ADDENDUM 1

ADDITIONS & RENOVATIONS TO GAINSBORO PUBLIC LIBRARY AND JACKSON PARK PUBLIC LIBRARY ROANOKE, VIRGINIA

BID NUMBER 08-09-01

TITLE REVISED FOUNDATION PLAN			
DRAWN BY CMF	CHECKED BY CMF	DATE 11/13/07	COMM. NO. 6501.03

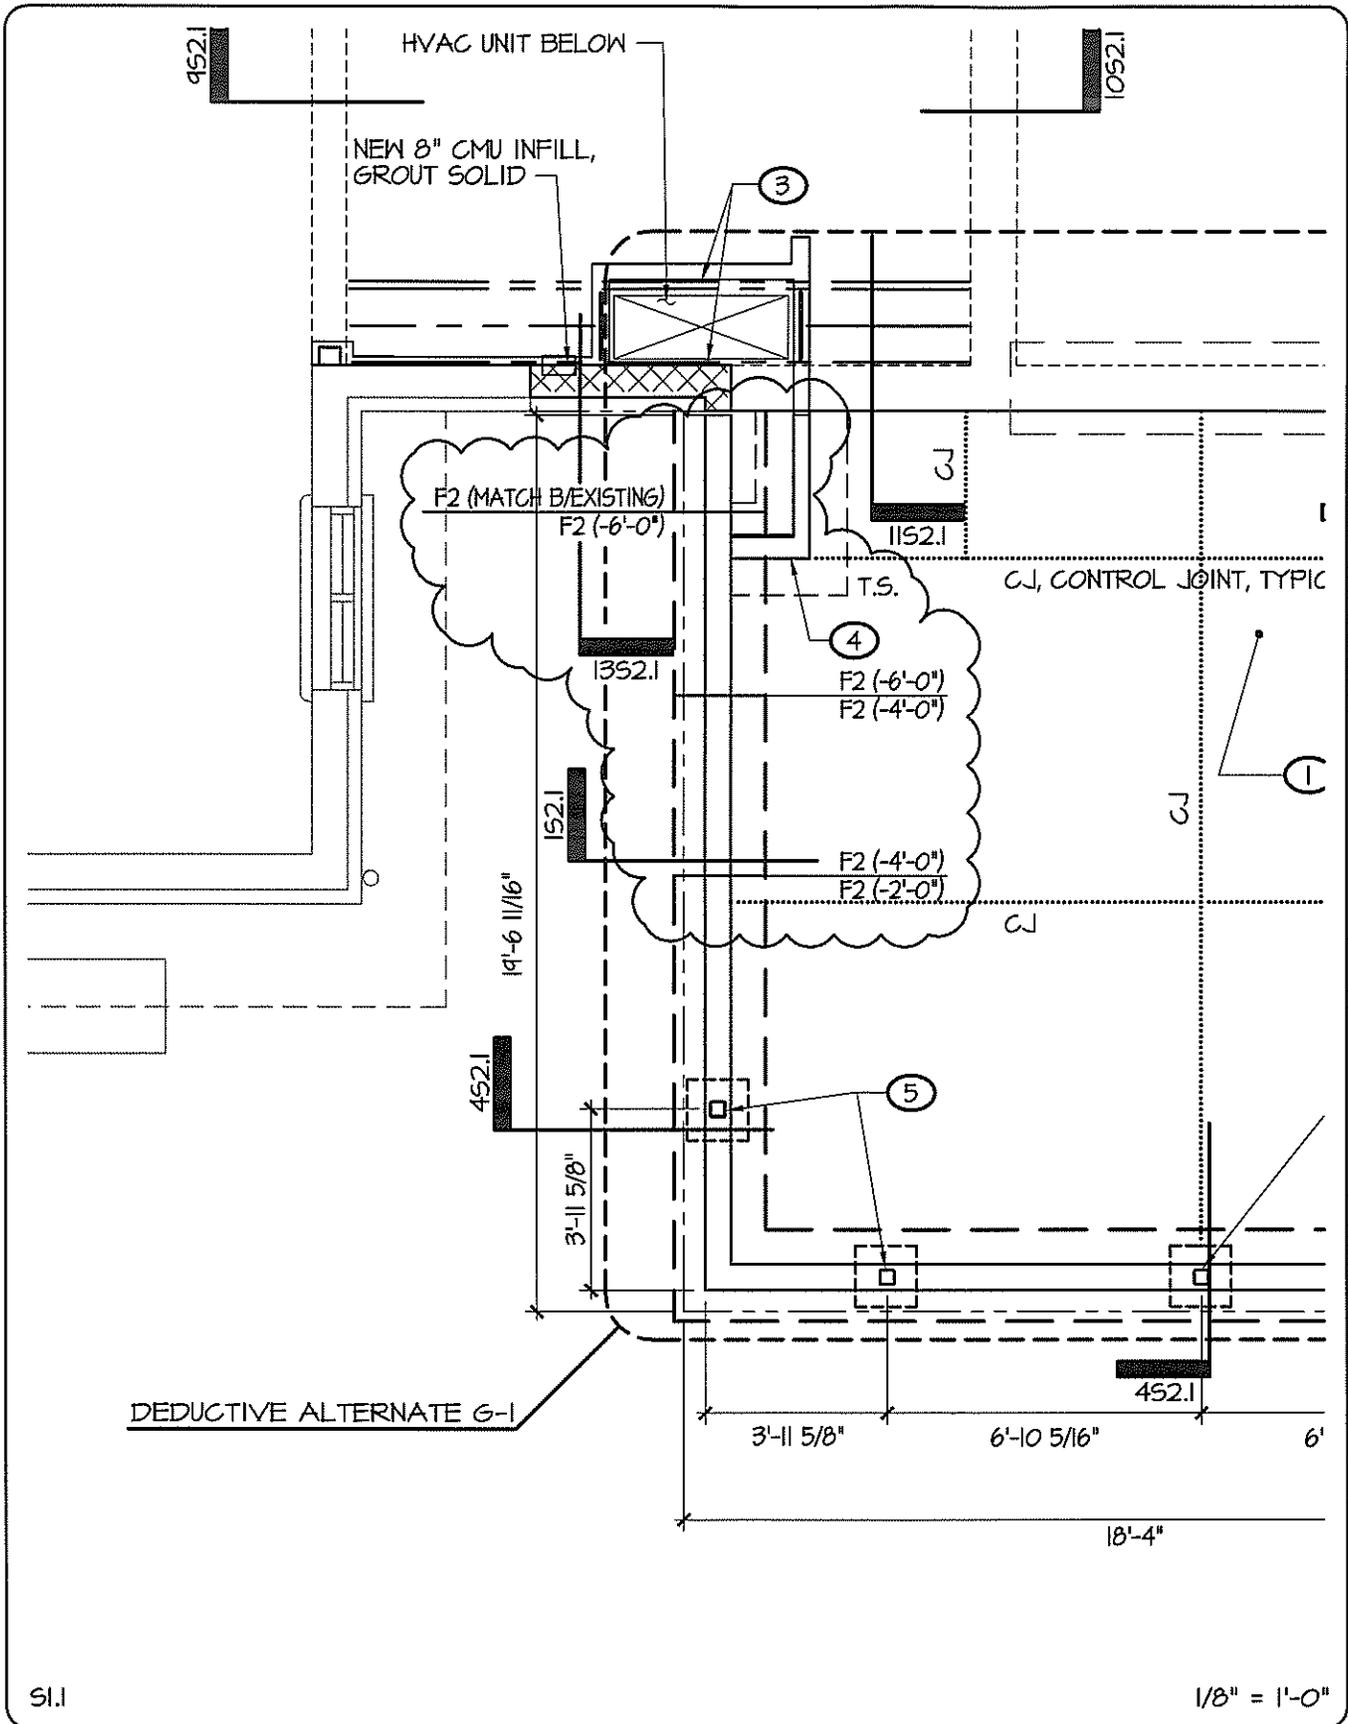
- Item 7. DRAWINGS, Sheet S1.1: Revise foundation plan per Supplemental Drawing No. 1 titled "Revised Foundation Plan," dated November 13, 2007, attached hereto.

TITLE REVISED DETAIL 1352.1

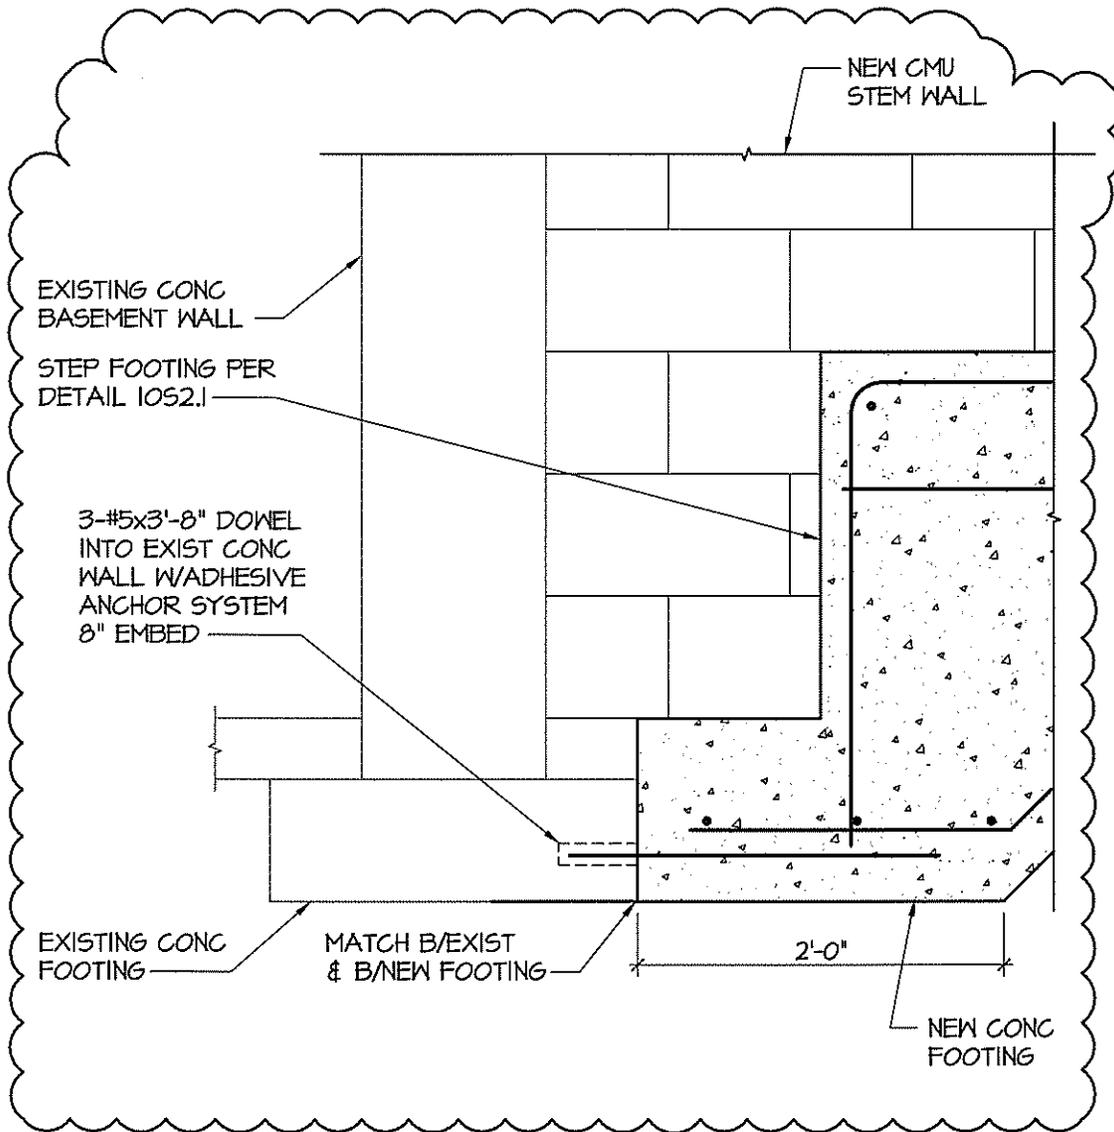
"When excavating adjacent to existing structure without basement, maintain a minimum 1:1 soil slope from edge of footing to avoid undermining existing footing per Owner's licensed geotechnical engineer's recommendations."
- Item 9. DRAWINGS, Sheet S2.1: Revise Detail "13" Supplemental Drawing No. 2 titled "Revised Detail 13S2.1," dated November 13, 2007, attached hereto.
